2.0 SITE CHARACTERISTICS

This chapter of the North Anna 3 combined license (COL) Final Safety Analysis Report (FSAR) addresses the geological, seismological, hydrological, and meteorological characteristics of the site and vicinity, in conjunction with present and projected population distributions and land use and site activities and controls

Figure 2.4.2.4-101 Site layout and sub-basin drainage areas

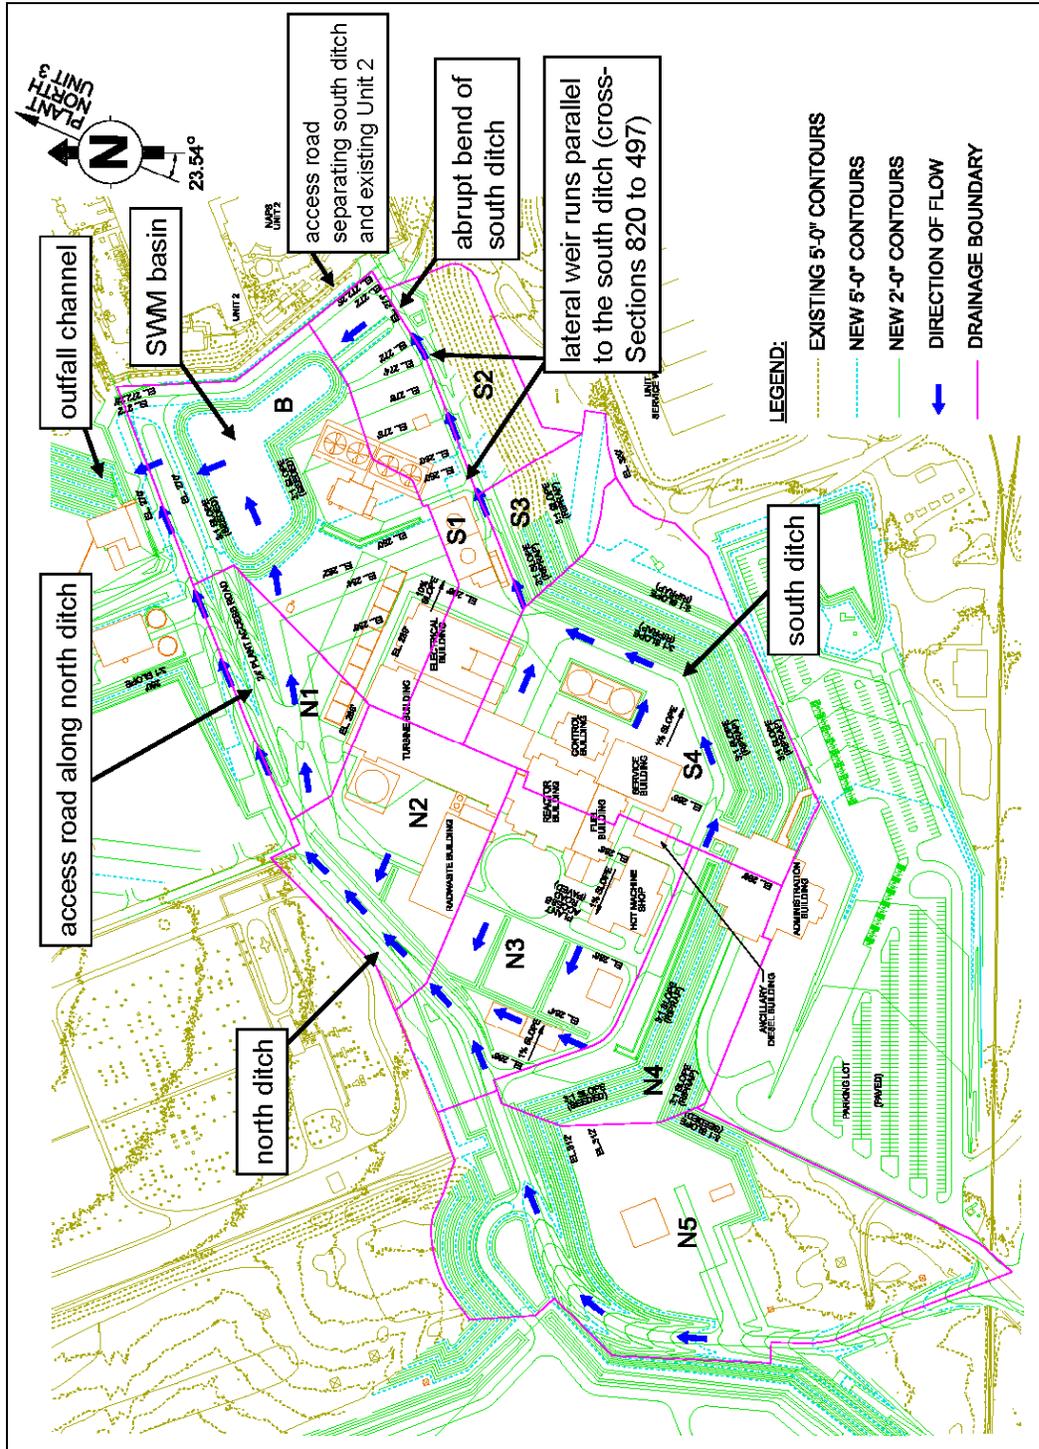
Supercritical velocities were computed in both the north ditch and south ditch during the PMP-generated flood. In the south ditch, supercritical velocities occurred from cross section 820 to 440 (see Figure 2.4.2.4-102). Water velocities along this reach of the south ditch ranged from approximately 8 to 12 feet per second. A hydraulic jump is produced in the south ditch near

A lateral weir structure along the south ditch provides overflow relief for cross sections 820 through 497 (see Figure 2.4.2.4-101). The applicant's simulation results indicate this structure conveyed approximately 139 cubic feet per second (cfs), with approximately 300 cfs remaining in the south ditch at the abrupt bend near cross-section 380. To evaluate the sensitivity of water surface elevations near this abrupt bend, the staff removed the lateral weir from the HEC-RAS input so that the south ditch conveyed the entire 439.1 cfs. The resulting water surface elevation at cross-section 380 increased to 272.24 feet, or 0.01 foot below the access road crest between the south ditch and the Unit 1 and 2 yard (see Table 2.4.2.4-101).

Figure 2.4.2.4-102 Site layout and HEC-RAS cross section locations

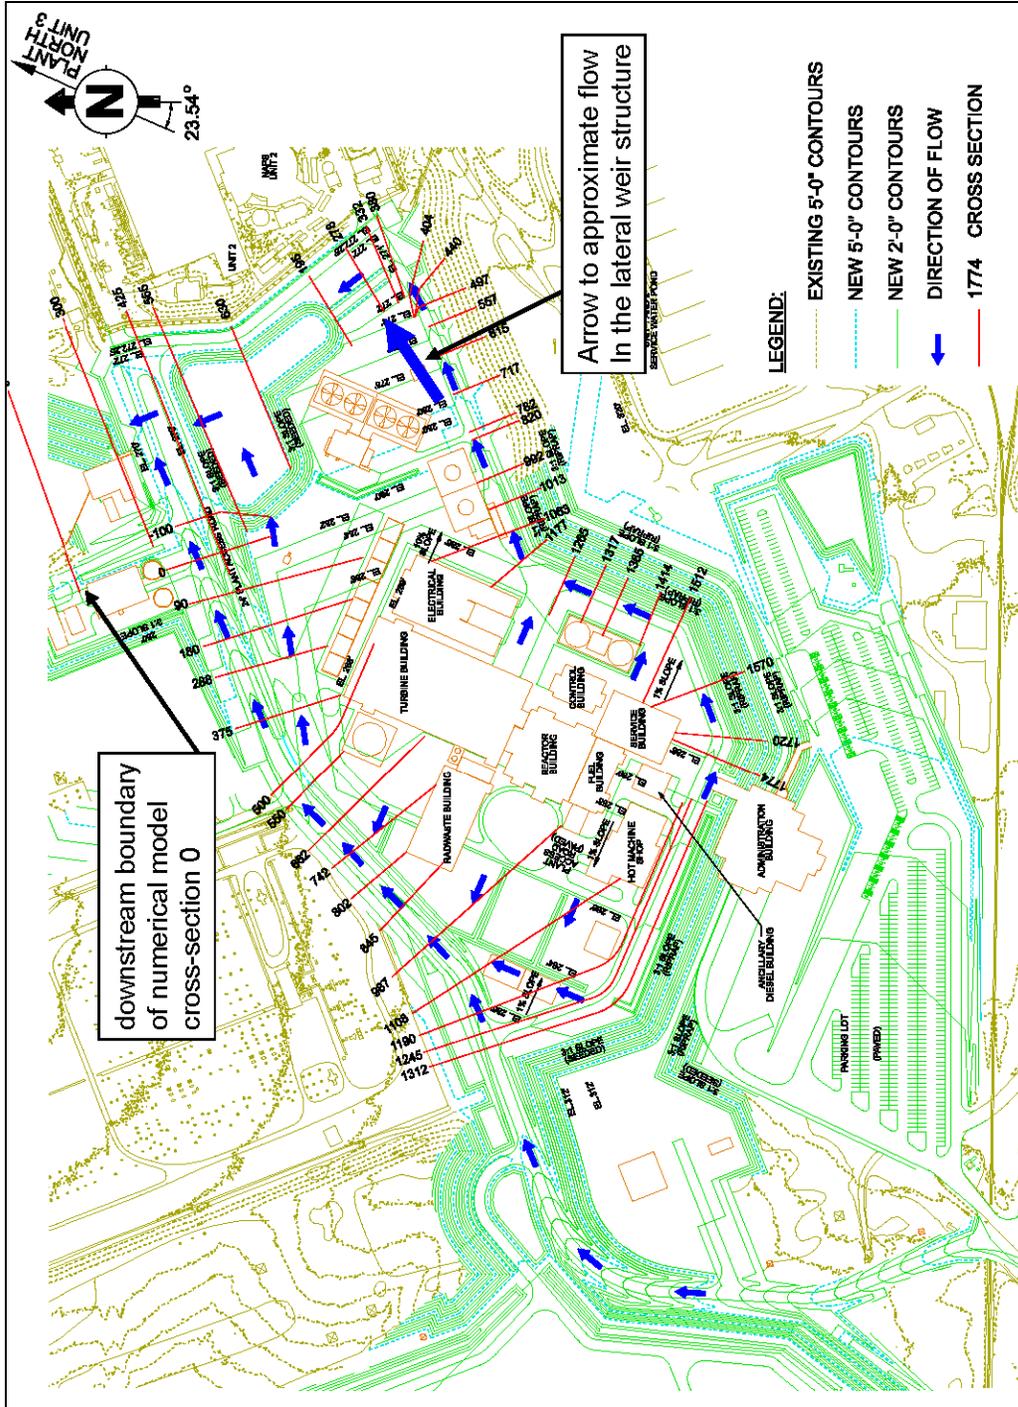
Staff performed a second sensitivity test of the lateral weir structure by altering the location where the weir flow reentered the south ditch (see Figure 2.4.2.4-102). The applicant's simulation specified that this flow would reenter the south ditch at cross section 278. The staff's simulation assumed that the flow ran parallel to the south ditch and reentered between cross sections 404 and 380. The resulting water-surface elevation at cross-section 380 was 272.24 feet, or 0.01 foot below the access road crest between the south ditch and the Unit 1 and 2 yard. These results are nearly identical to the first sensitivity test where the lateral weir was completely removed and all flow was confined to the south ditch (see Table 2.4.2.4-101).

Figure 2.5.4-5 Unit 3 Boring Locations (FSAR Figure 2.5-221)

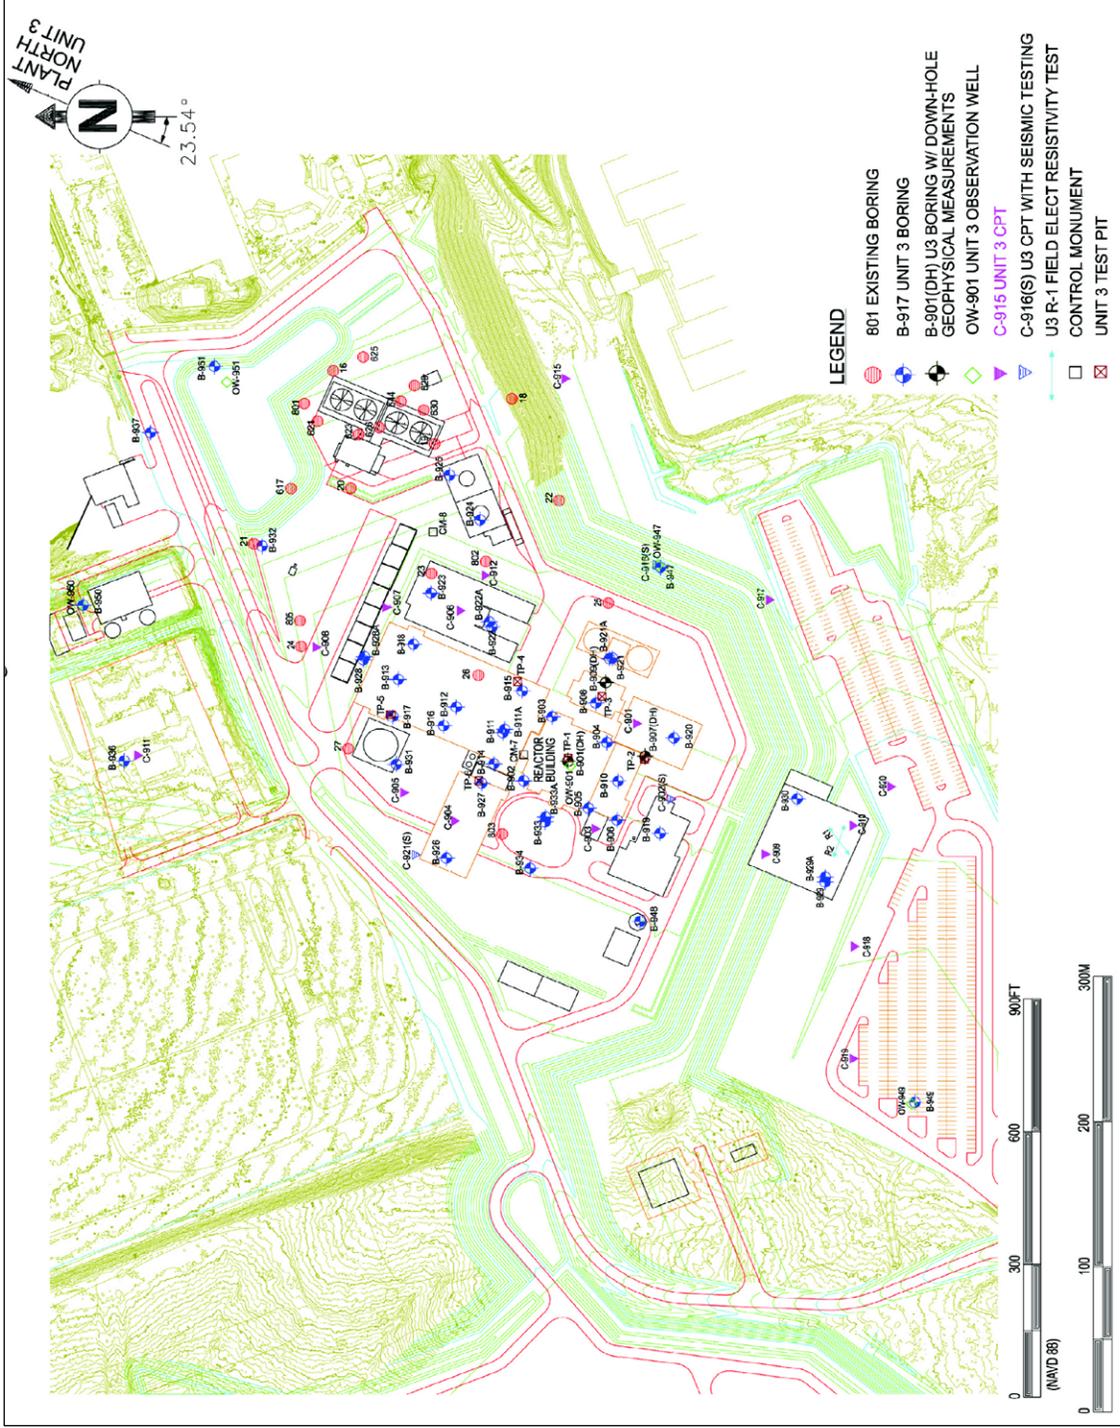
The staff reviewed the additional borings performed by the applicant to confirm engineering properties and the stability of soil and rock underlying future plant structures, systems, and components. As part of this review, the staff also examined the site exploration points for the Unit 3 subsurface investigations, including FSAR Figure 2.5-221 (see Figure 2.5.4-5 of this SER), which shows the locations of additional boreholes, observation wells, CPTs, electrical

resistivity tests, and test pits. This information was considered by the staff in concert with the exploration points outside of the power block area (see FSAR Figure 2.5-222). The staff

concluded that the additional boreholes are sufficient to resolve DCD COL Item 2.0-29-A, which requires the COL applicant to complete additional borings at the COL site to address the provisions listed in ESBWR DCD Table 2.0-1, regarding stability of subsurface material and foundation requirements.

Figure 2.5.5-1 Excavation Grading Plan with Boring Locations (FSAR Figure 2.5-255)

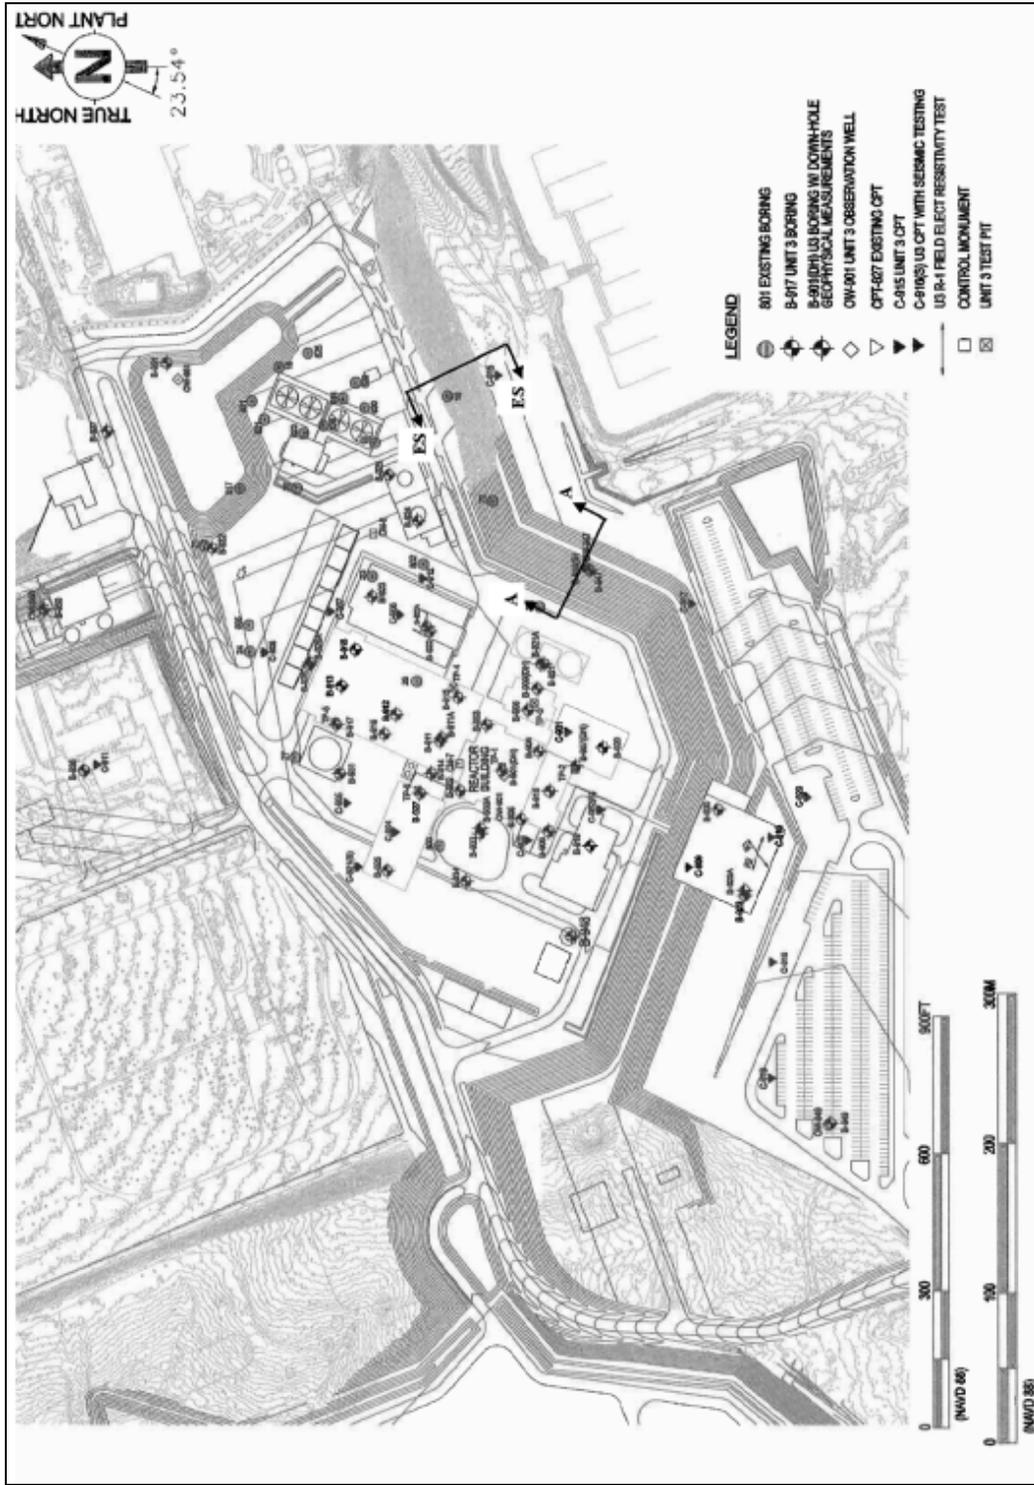
FSAR Figure 2.5-255 also shows existing slopes, including one that runs in a northeasterly direction, to the south of abandoned Units 3 and 4 and existing Units 1 and 2. The applicant performed a new topographic survey for Unit 3 showing that the slope is about 2.4-horizontal to 1-vertical (2.4h:1v), with a maximum height of 13.1 m (43 ft) based on the final grade for Unit 3. The applicant stated that the maximum depth of the storm water basin to the northeast of the main plant area is 6.7 m (22 ft), cut at a 3h:1v slope. The applicant did not address the stability of this slope because the storm water basin sides do not affect the safety of the plant or its peripheral structures. The existing 2.4h:1v slope (Slope ES on Figure 2.5.5-1) was excavated during the construction of Units 1 and 2. Because the top of this slope is about 61 m (200 ft) from the top of the existing service water reservoir (SWR) embankment, the applicant concluded that any potential instability of the slope will not impact the stability of the embankment. However, the applicant acknowledged that material from sloughing or collapse of these slopes could impact the new diesel tanks and/or service water cooling tower.

The applicant identified the only slopes that could impact facilities at the Unit 3 site as cut slopes that surround and ascend from the southern edges of the plant. The applicant described these new slopes as cut at 3h:1v into the existing natural ground surrounding the plant, with a height of 10.7 m (35 ft) to the southeast of the FWSC (Slope A-A' on Figure 2.5.5-1). The applicant also stated that, in general, the instability of this slope will not impact the foundation stability of seismic Category I facilities because the facilities are either founded on stable compacted crushed rock fill, or are far away from the Category I structures. However, material from sloughing or collapse of the slope could impact the facility, because the base is about 16.8 m (55 ft) from the FWSC. Therefore, the applicant concluded that Slope A-A should be considered the critical slope in the area.

Figure 2.5.5-2 Output of Slope Stability Analysis Using the Bishop Method

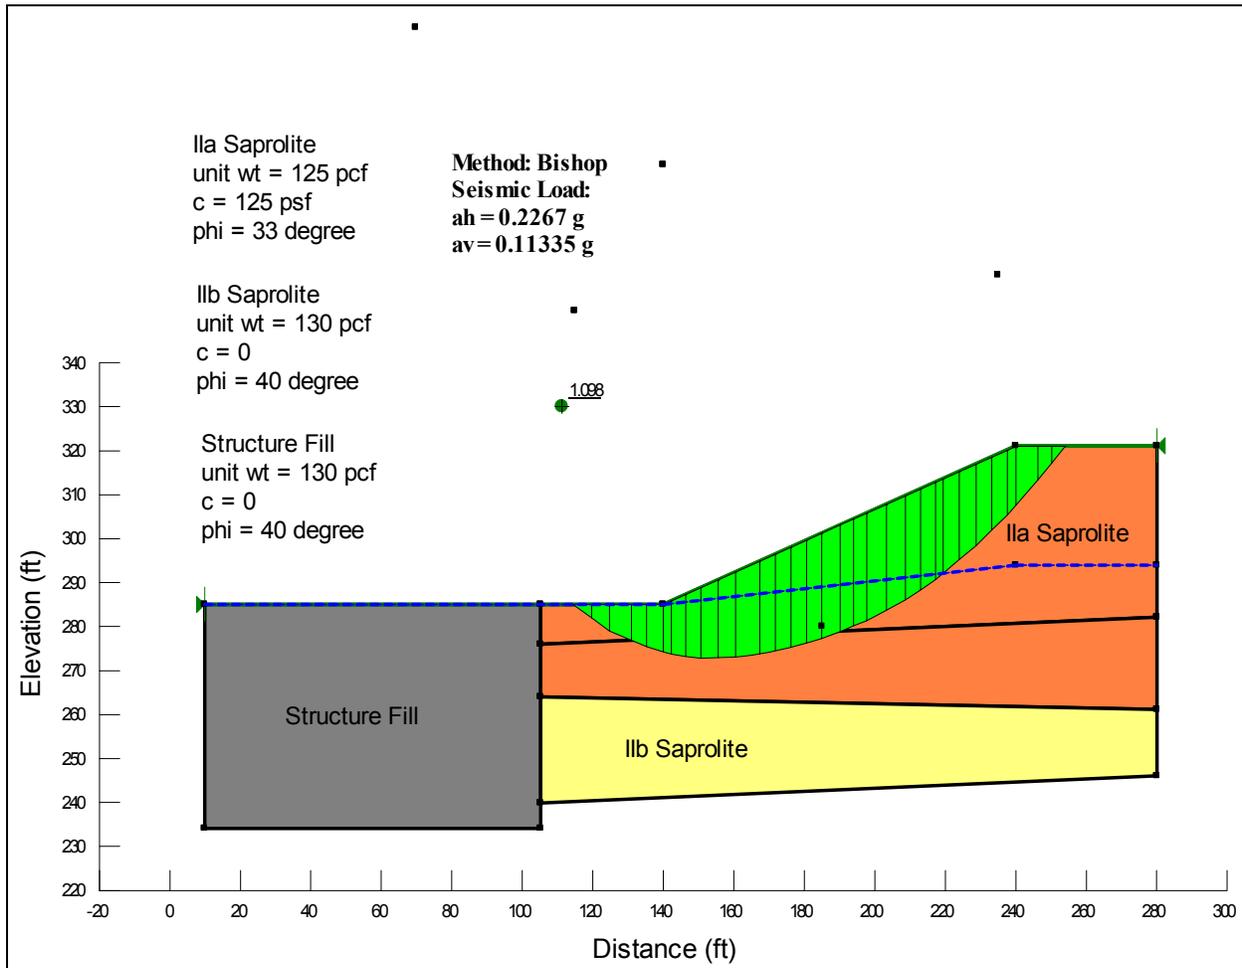
The staff considered the applicant’s statement that all slope stability analysis methods have their own advantages and limitations, and the Bishop method may or may not give the most conservative results. Accordingly, the staff conducted an independent confirmatory analysis for a selected slope using the information in Figure 2.5-266 of the FSAR. The staff obtained the FS using GeoSlope—the same computer software used by the applicant. The calculated FS values are listed below, and the results from one of the analyses are illustrated in Figure 2.5.5-2.
